Invitation for Bid No. 2021-090

Union County Structured Cabling & Audio Visual

ADDENDUM No. 1

ISSUE DATE: July 23, 2021

AVOO1

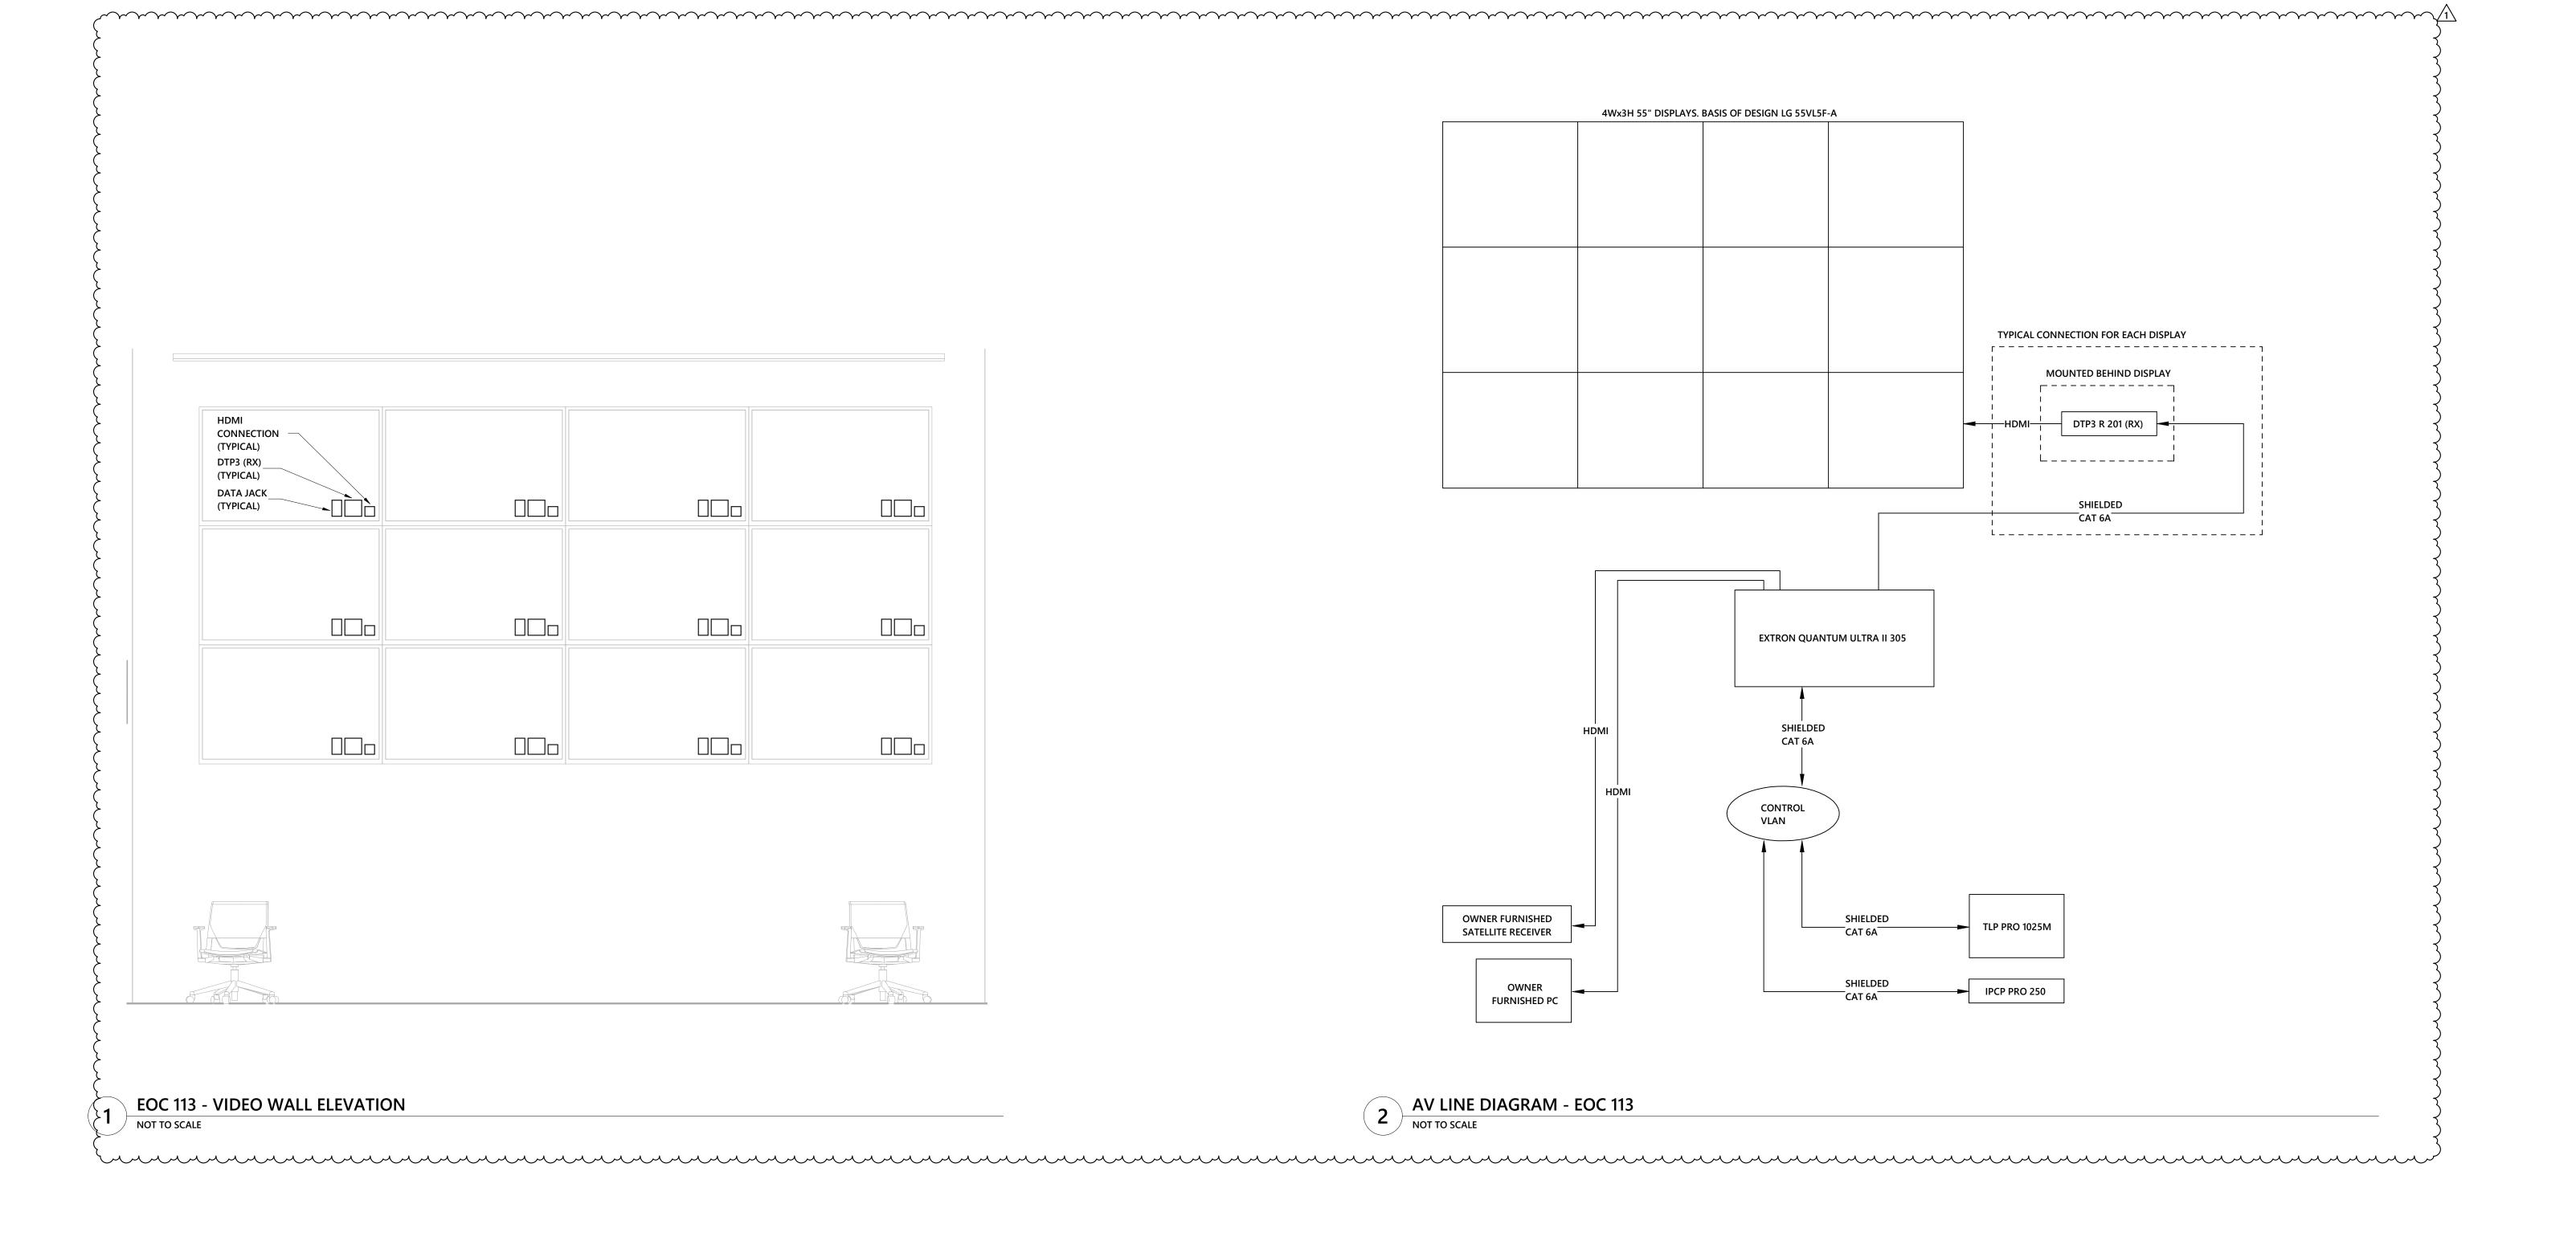
- e) Telecommunications Sheet TE301, (Revision 1).
 - 1) Removed all Wall Plated (WP) symbols from Telecom Plans.
- f) Audio Visual Sheet AV001 (SO), (Revision 1).

- 1) Modified Wall Plated (WP) description.
- g) Audio Visual Sheet AV403 (SO), (Revision 1).
 - Modified Enlarged Plans #1and #2.
- h) Audio Visual Sheet AV404 (SO), (Revision 1).

AV404

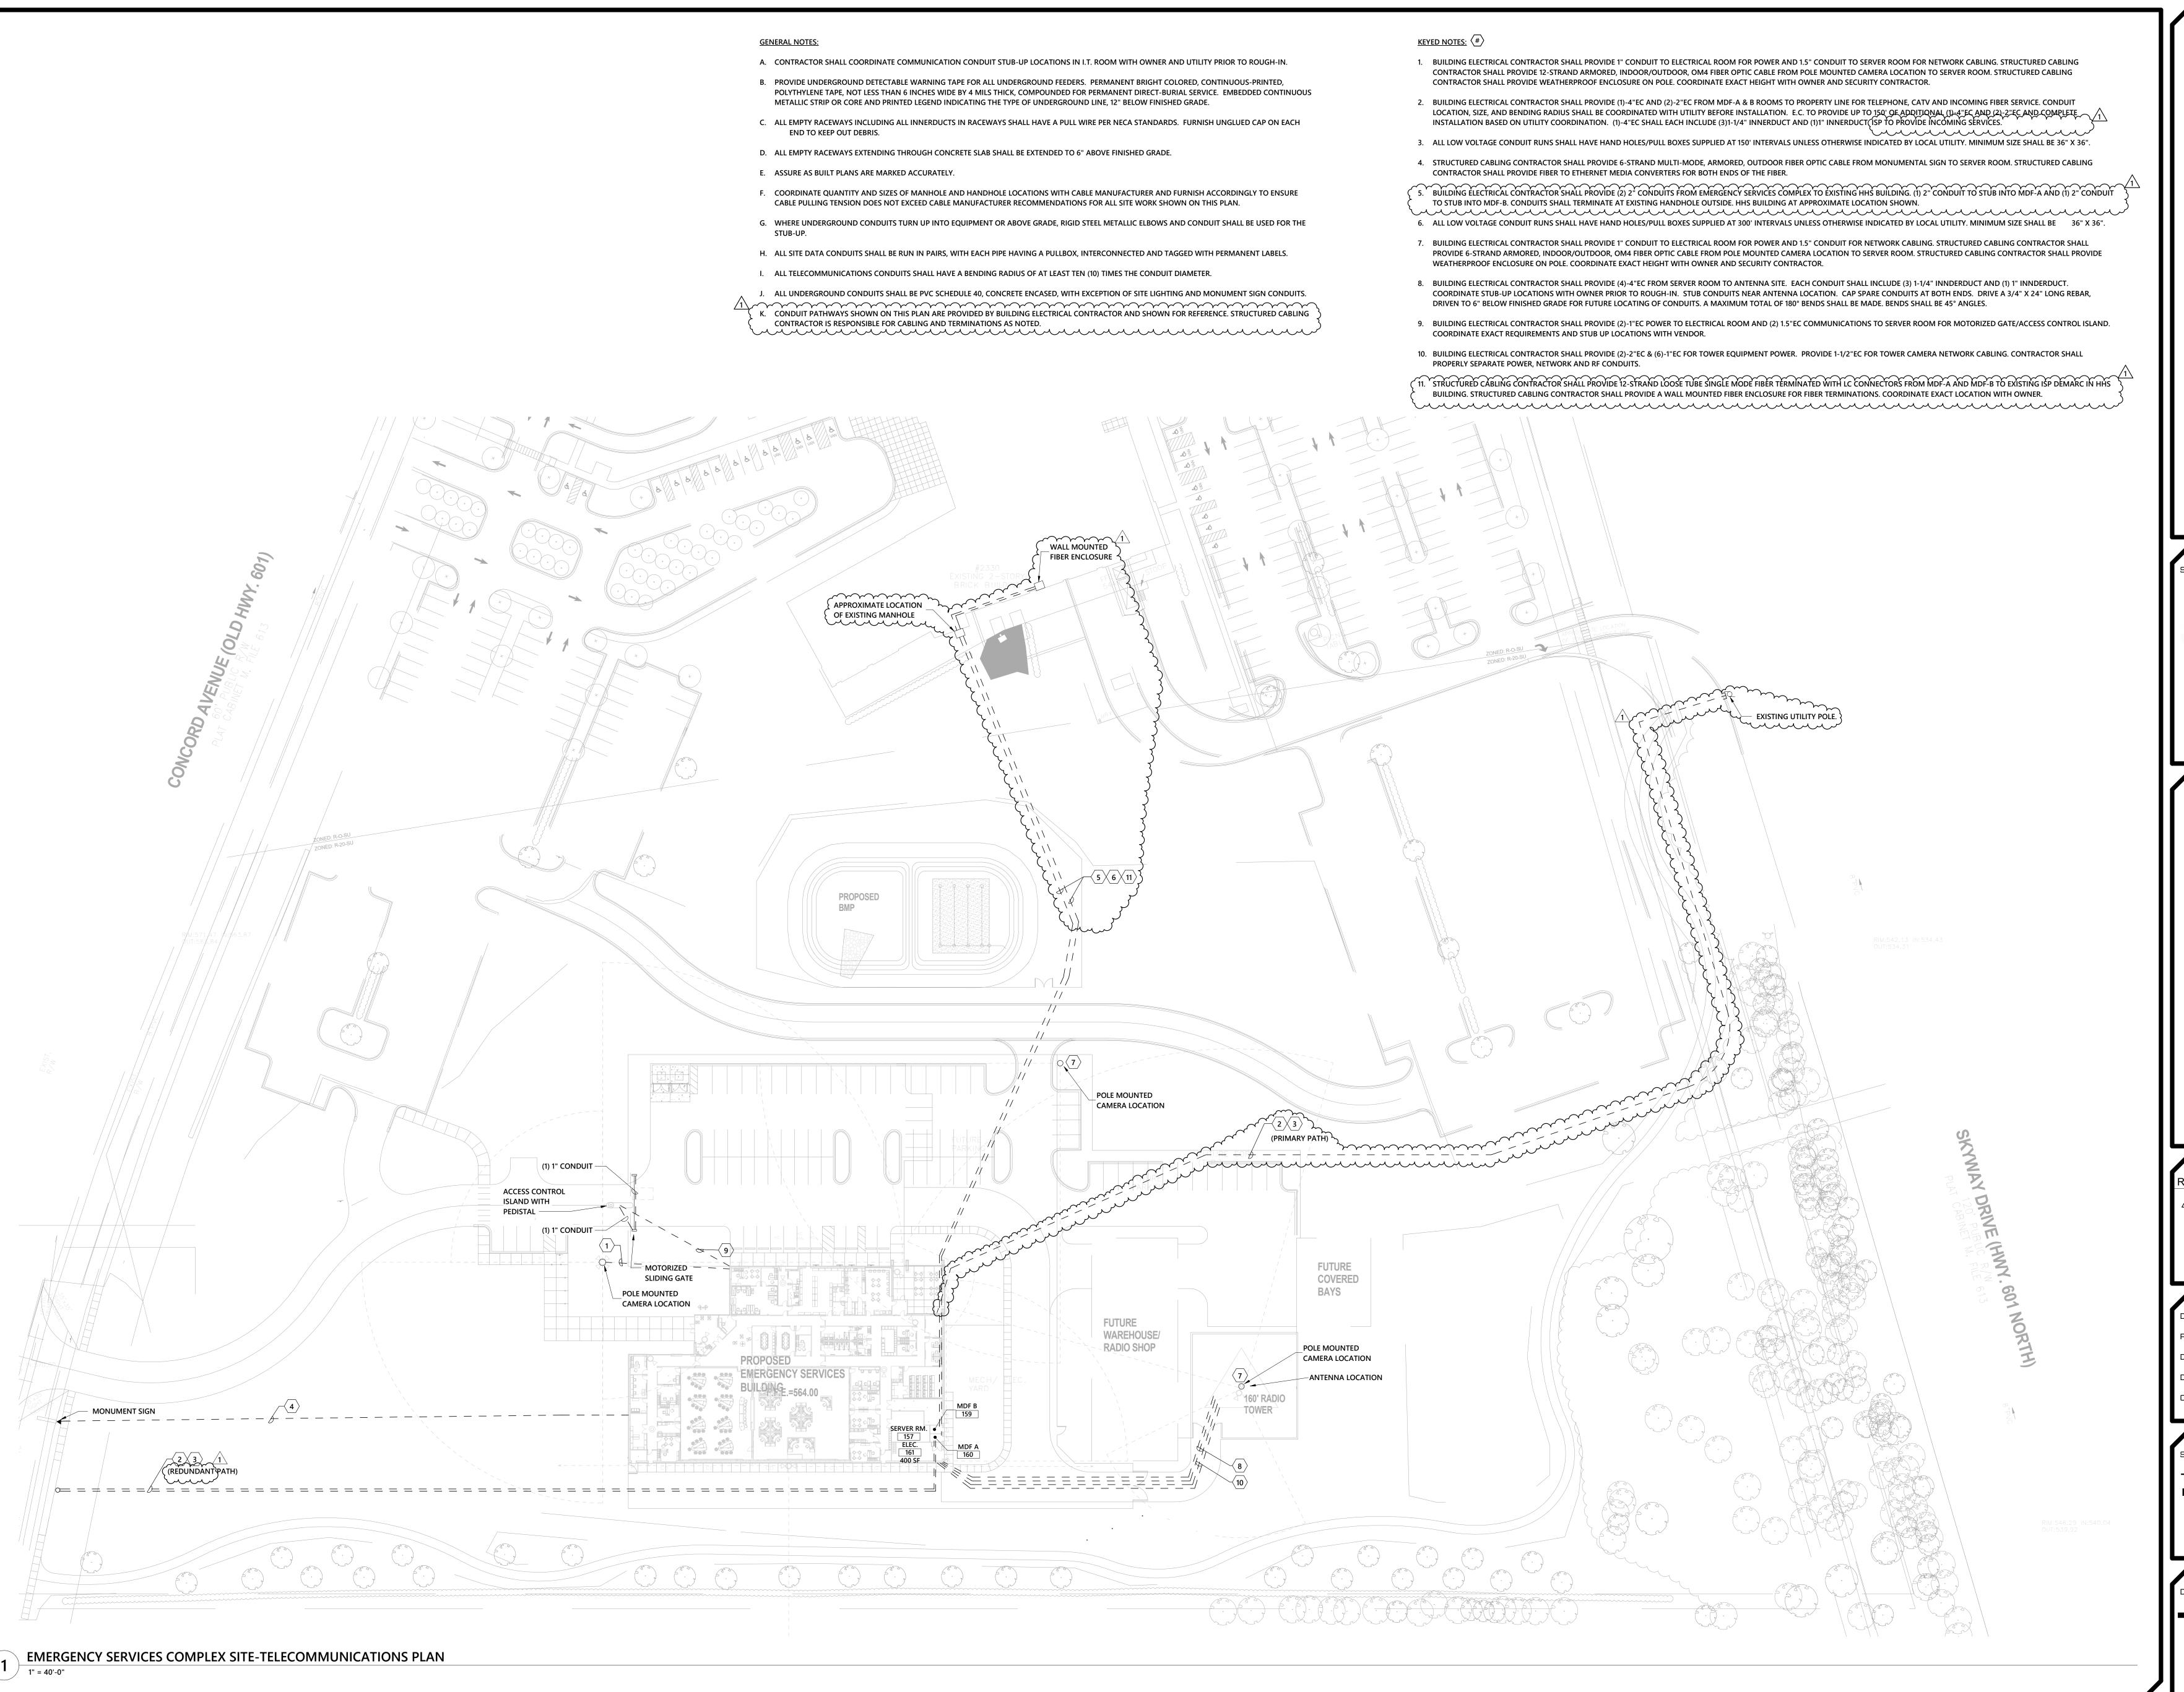
- 1) Modified Enlarged Plans #1and #2
- i) Audio Visual Sheet AV501 (SO), (Revision 1).
 - 1) Removed Projector from Training Room 1400.
 - 2) Added Video Wall text to Training Room 1400.

//TE101

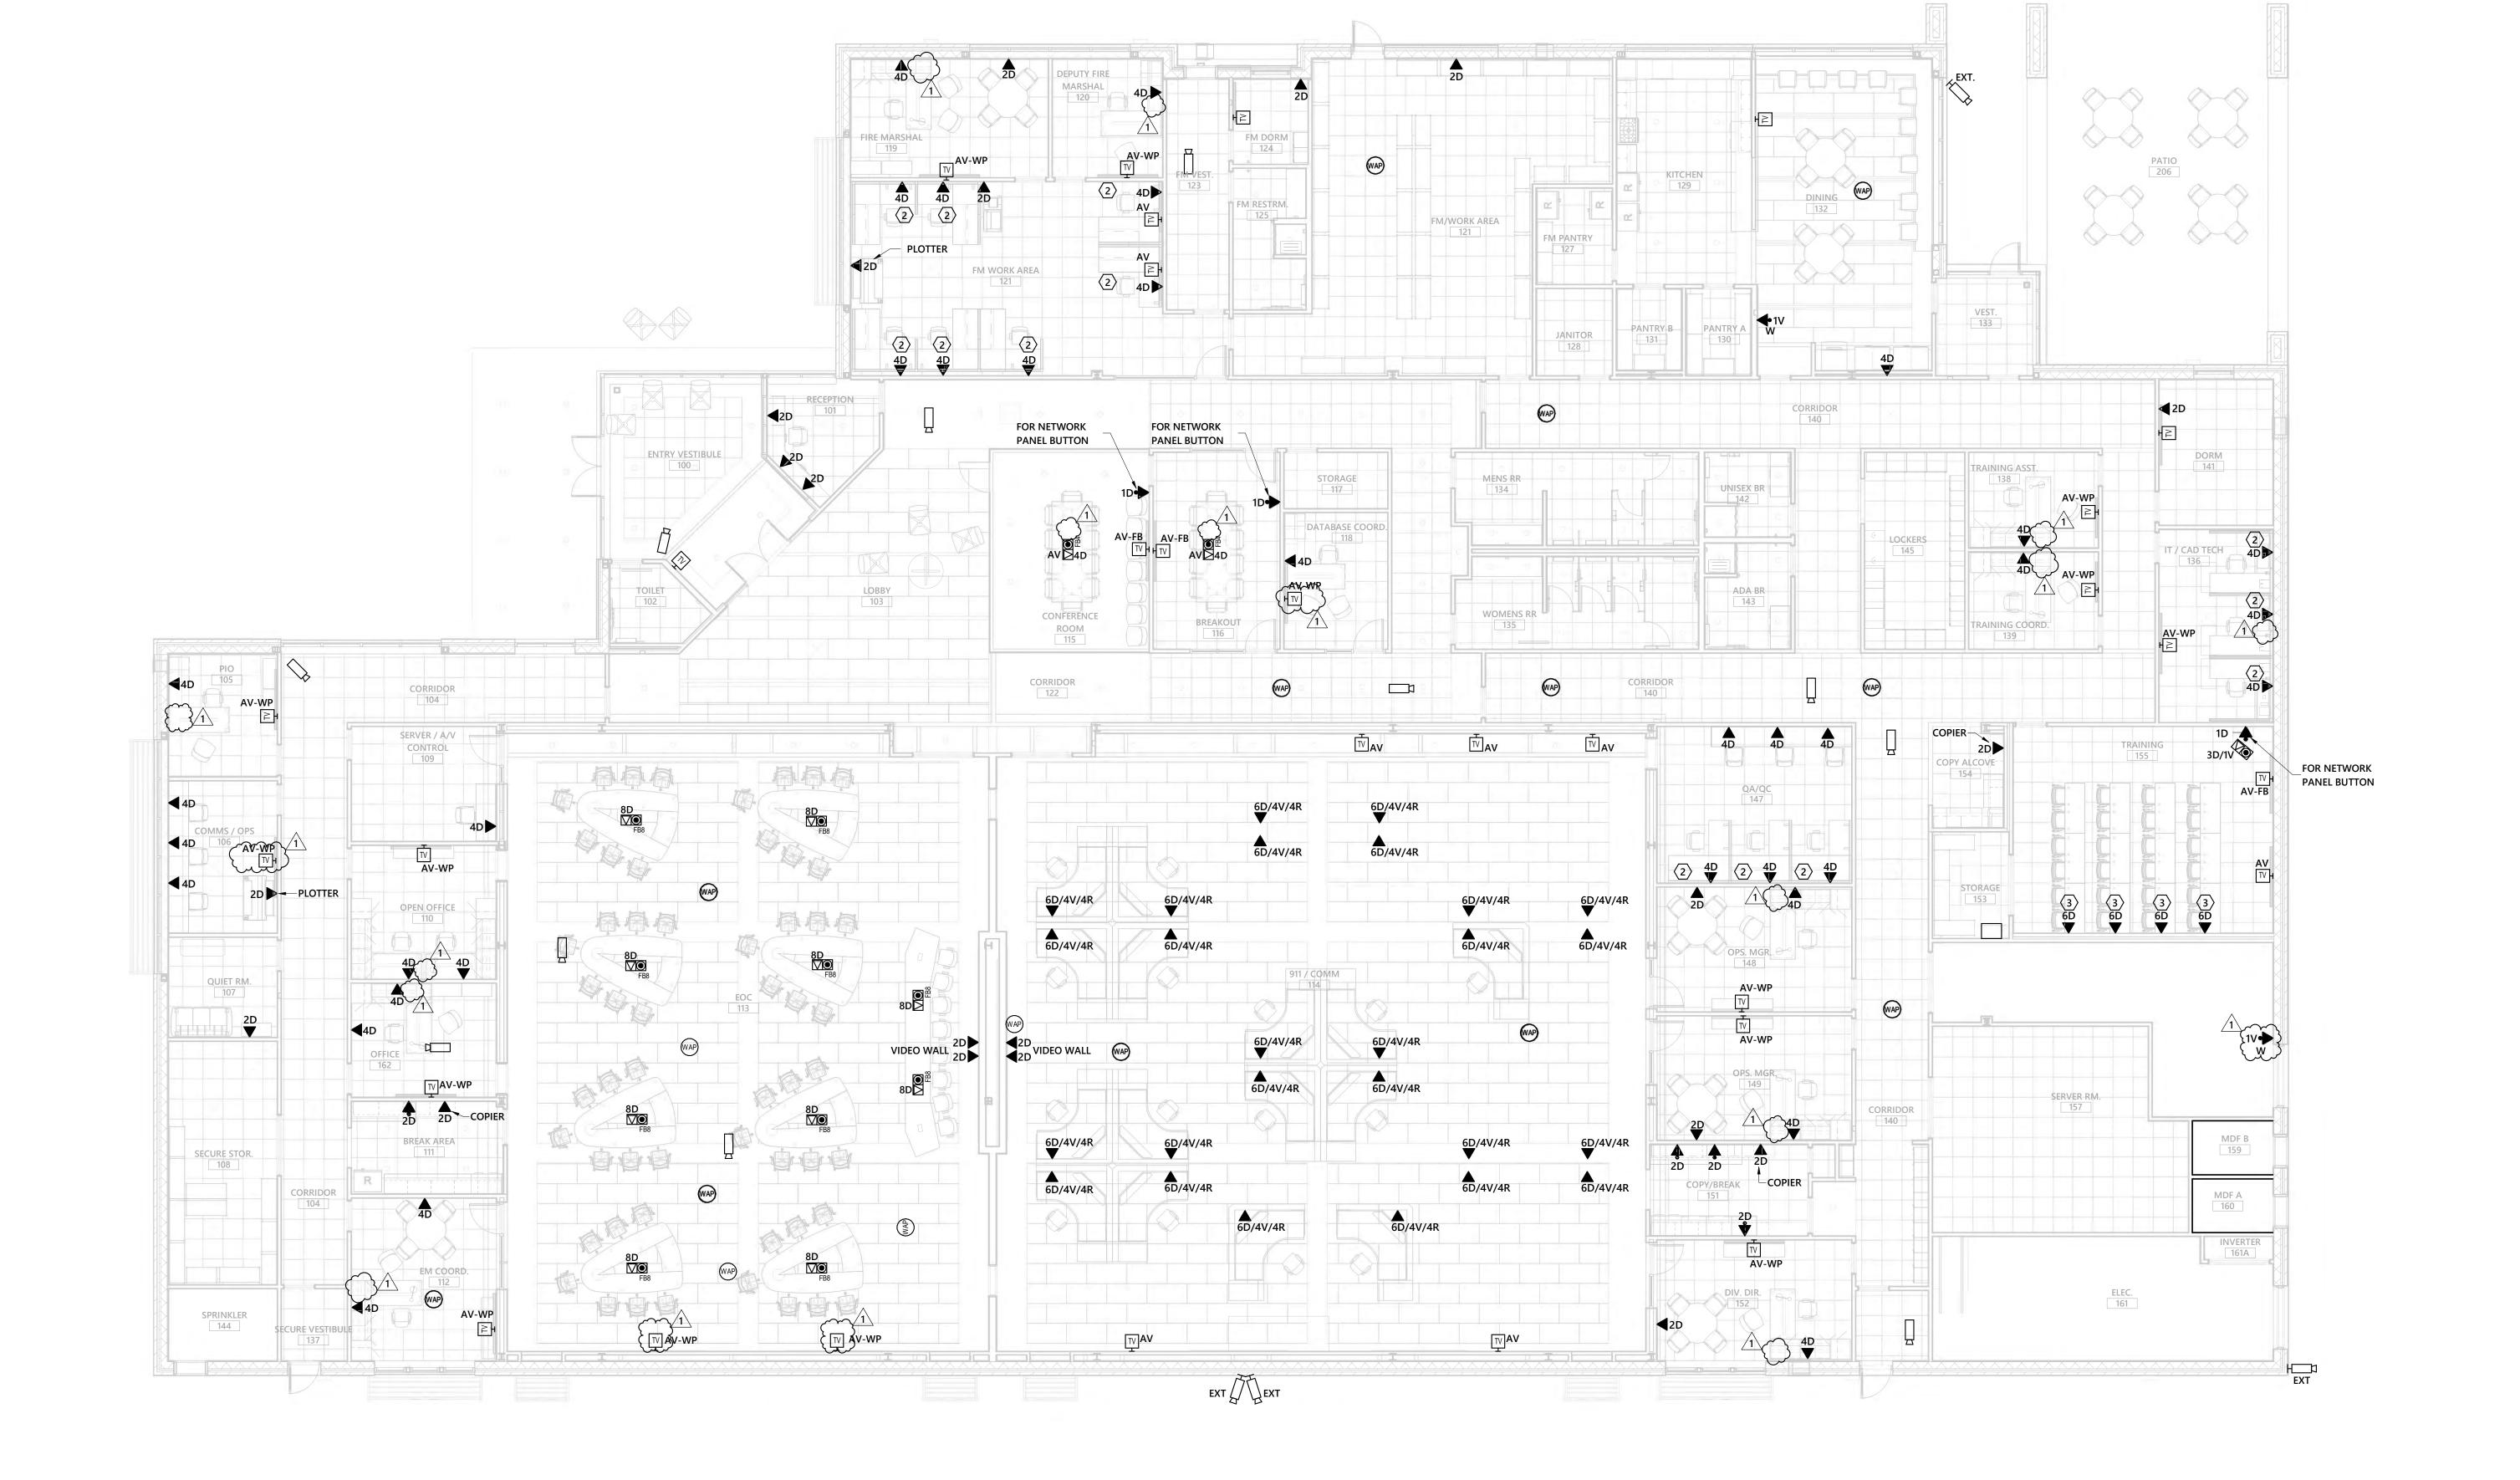
- D. MODIFICATIONS TO DRAWINGS
 - 1.14 This Addendum includes the attached full sheets:
 - a) Telecommunications Sheet TE101 (ESC), (Revision
 - 1) Added directions to Keyed Note #2.

- 2) Edited Keyed Note #5.
 - 3) Added directions to Keyed Note 1.
 - 4) Added General Note (K).
 - 5) Adjusted conduit pathways.

- b) Telecommunications Sheet TE101 (ESC), (Revision 1).
 - 1) Removed Keyed Note #1.
 - 2) Added subscript to elevated Data Port in Mech 156.
 - 3) Removed all Wall Plated (WP) symbols from Telecom Plans.
